TC1766

32-Bit Single-Chip Microcontroller

TC1766 Documentation Addendum

Revision History: **V1.2 2007-04**

Figure 22-61 Output Multiplexer

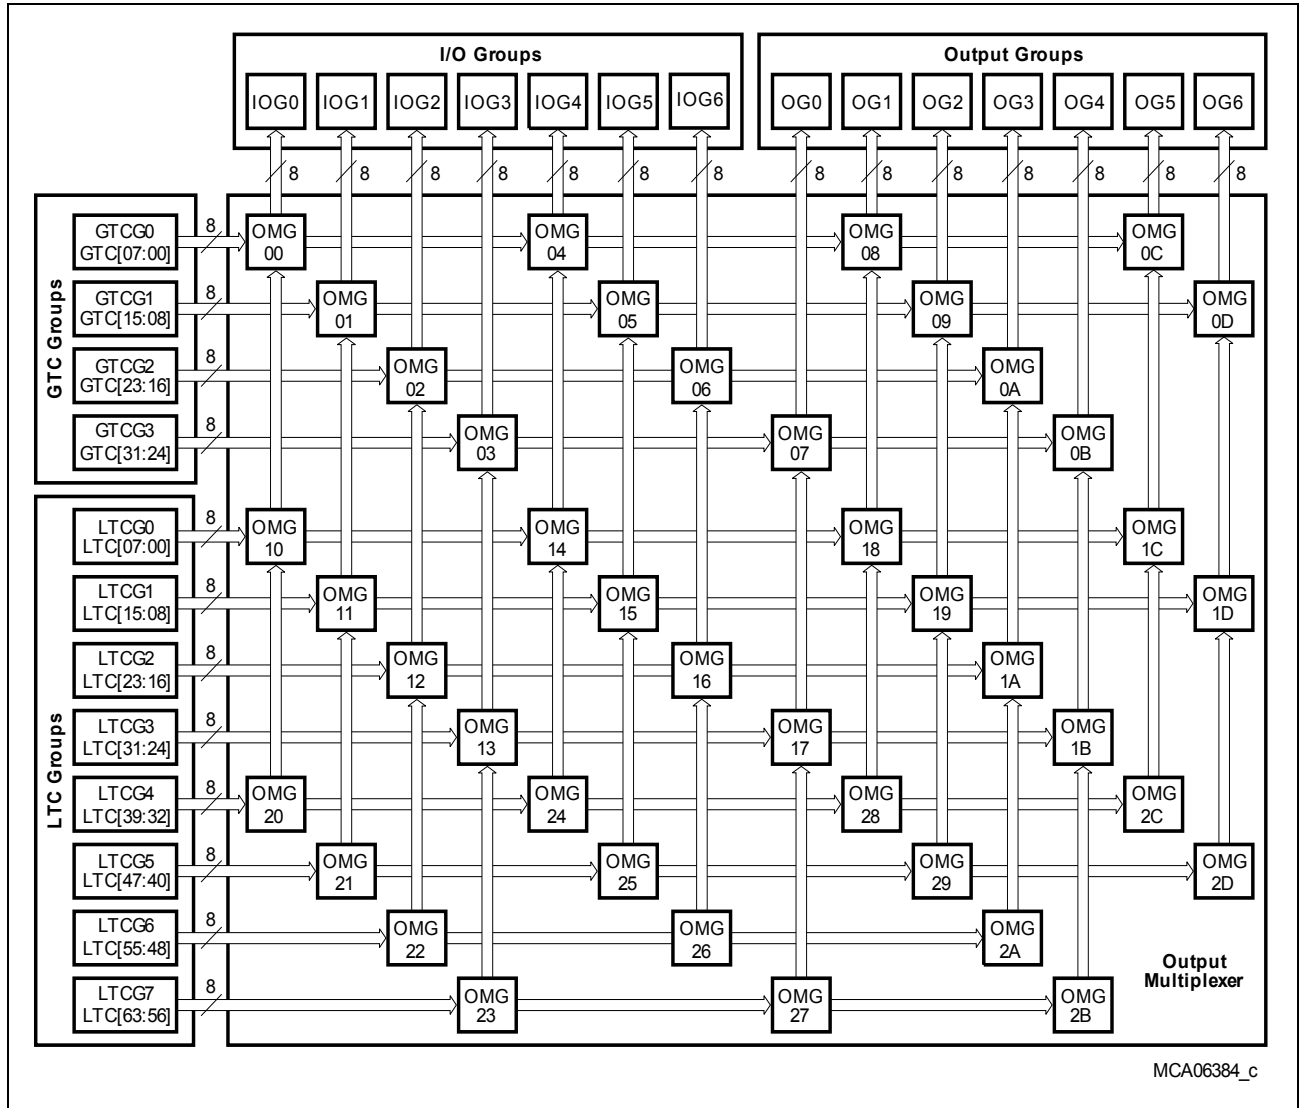
Figure 22-61 should be updated with the below figure:

Figure 22-63 Output Multiplexer Group (Programmer's View)

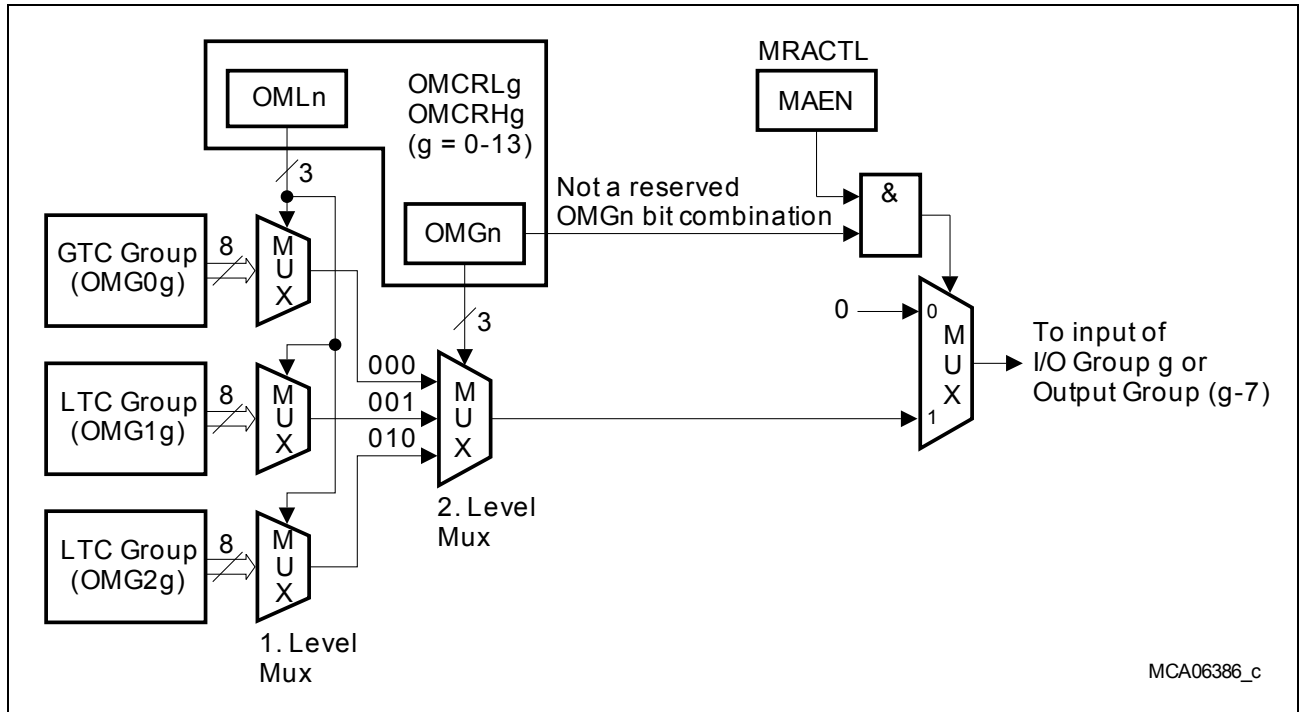
Figure 22-63 should be updated with the below figure:

Figure 22-64 GTC Input Multiplexer

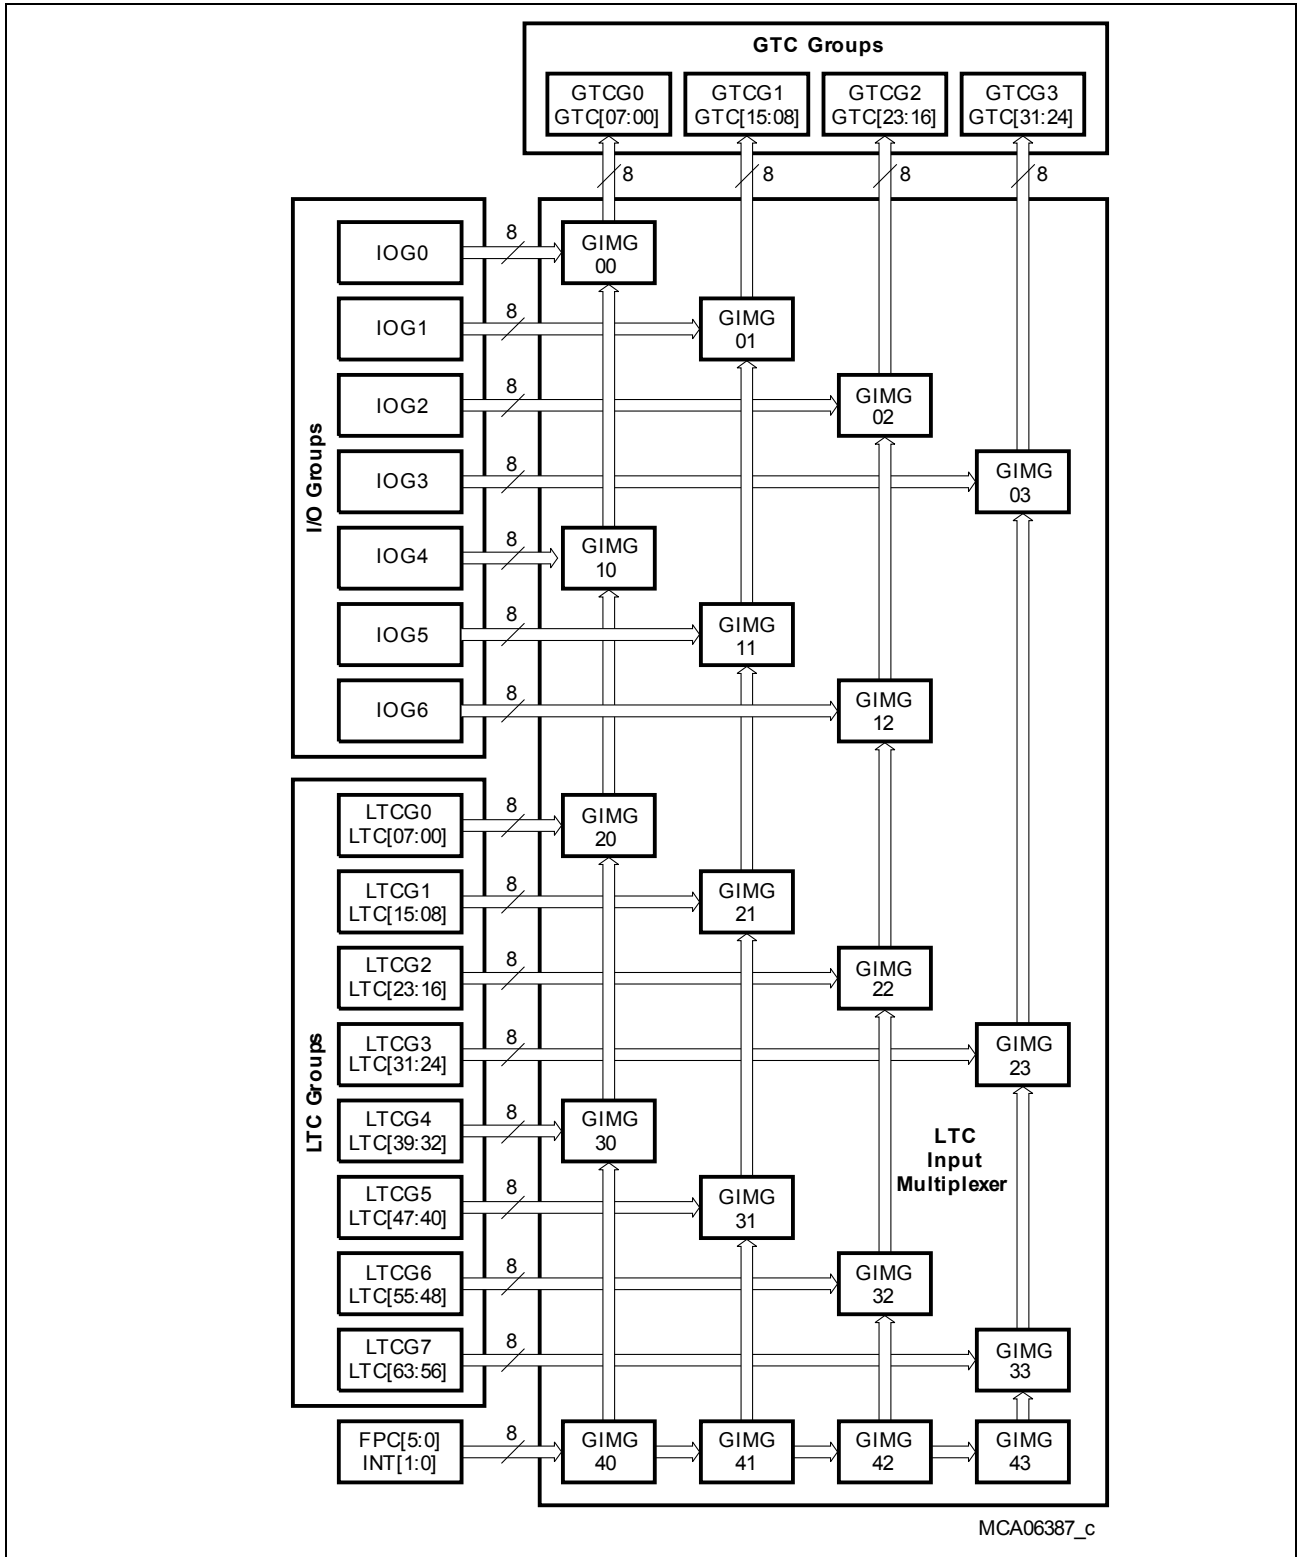
Figure 22-64 should be updated with the below figure:

Figure 22-67 LTC Input Multiplexer

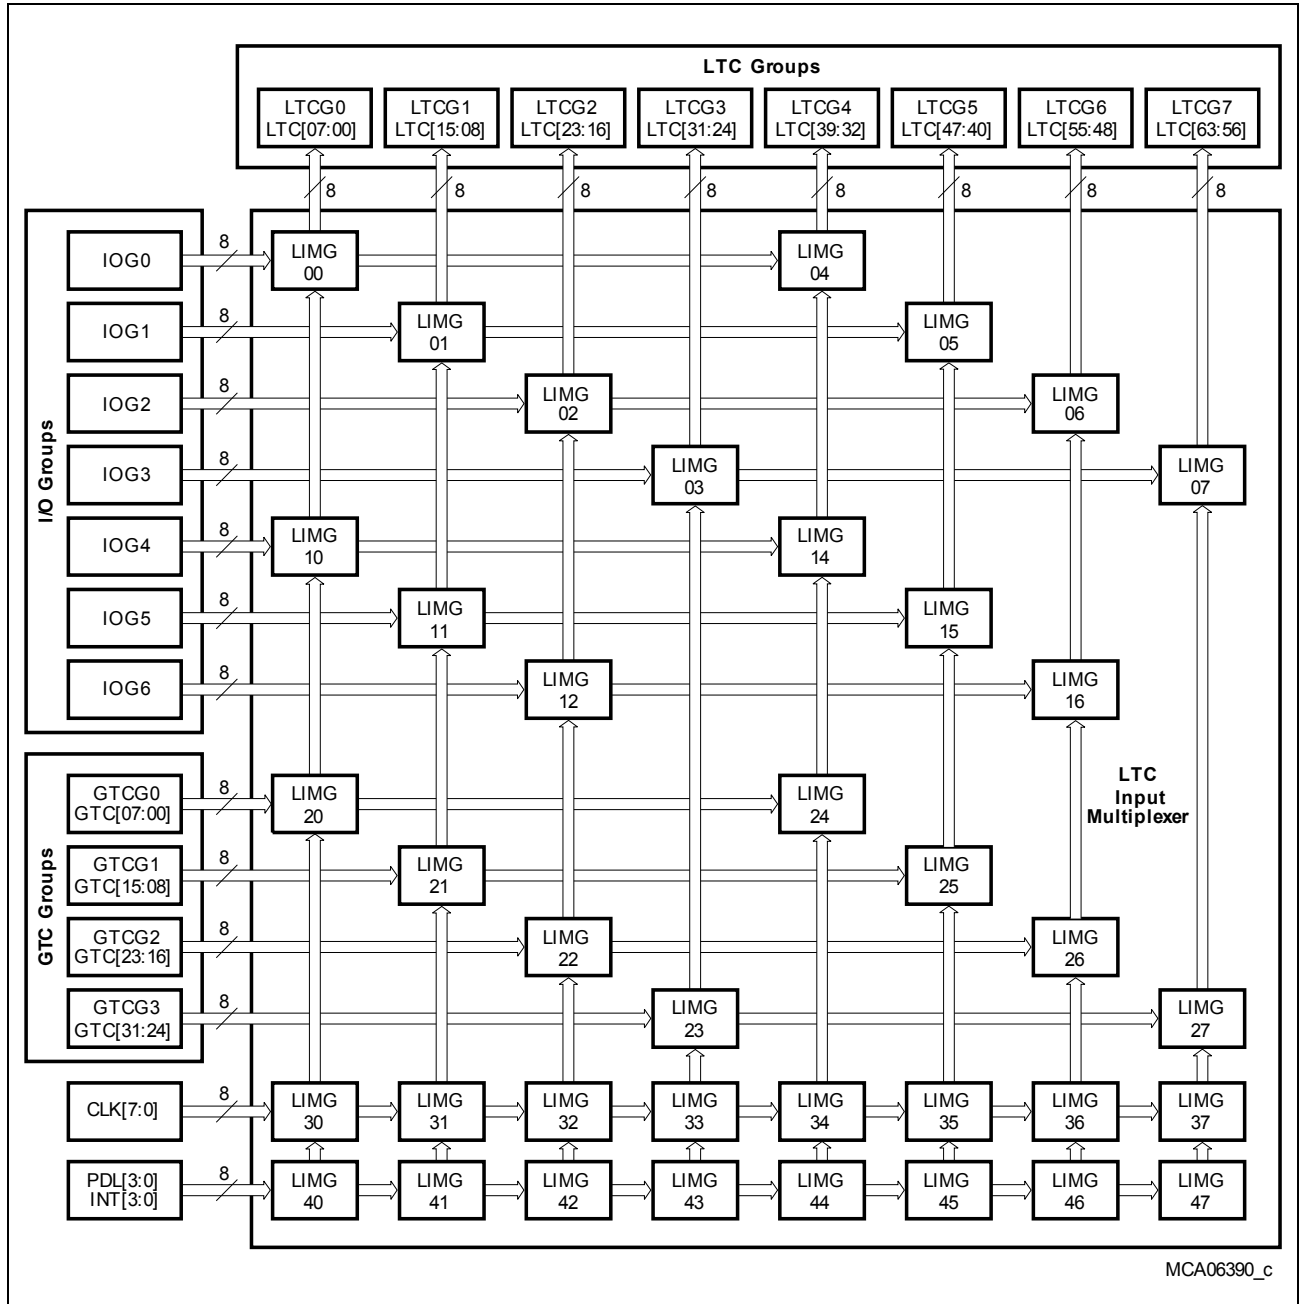
Figure 22-67 should be updated with the below figure:

Figure 22-75 I/O Port Line Assignment

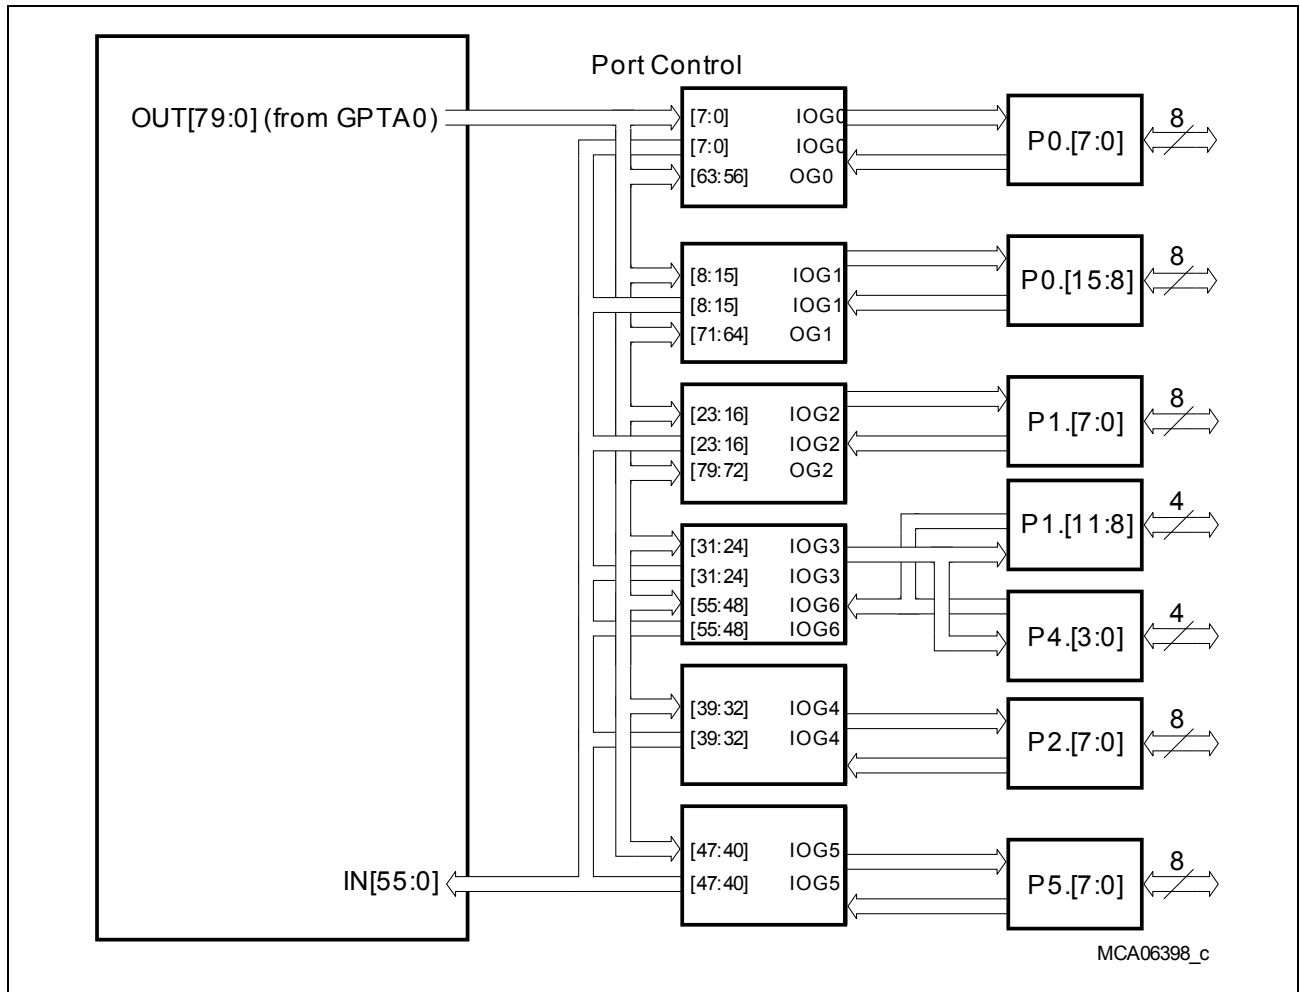
Figure 22-75 should be updated with the below figure:
